Product Change Notification

PCN-PCC-7926-2022

Description for Product Change Notification

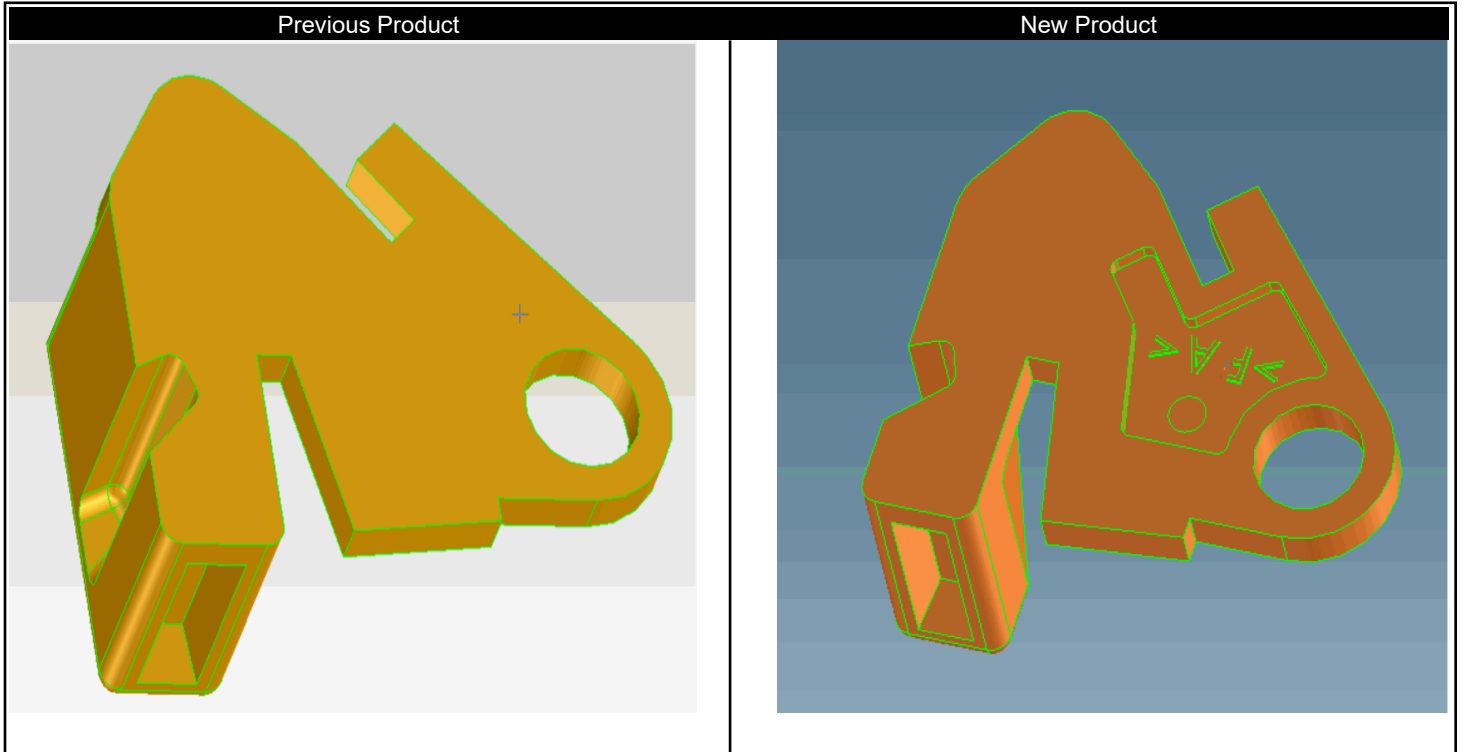
As part of the ongoing improvement process, the appearance of the FFKDS/H1-V1 rocker lever is being changed. The rocker lever will have an additional inlet (see drawing), but this will only be visible from the outside on some customer-specific versions without a cover. This change means that the injection molding process will be more stable in future. The technical data and external dimensions remain unchanged.
